CONSTRUCTION SUMMARY

Lindsay 2017 Developments Inc. / Sugarwood

Lot/Unit: 175 Block 94 Phase/Building: 1 Model/Floor Plan: Mitchell Lake(2002)Elev A
Opt Ensuite 3Bed 2.5Bath

Sketch
#1

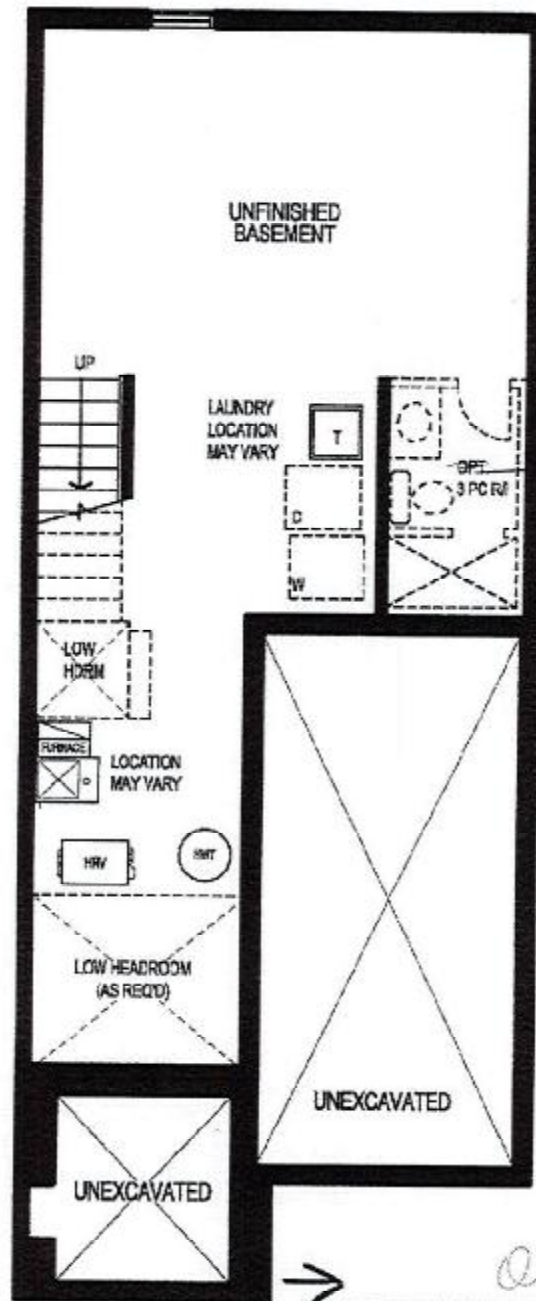
Inv.5459	1 - To supply & install the 3pc. rough in in the unfinished basement... see sketch # 1	
Line 70269	Note:	
16Mar22 / 16Mar22

3pc R/I
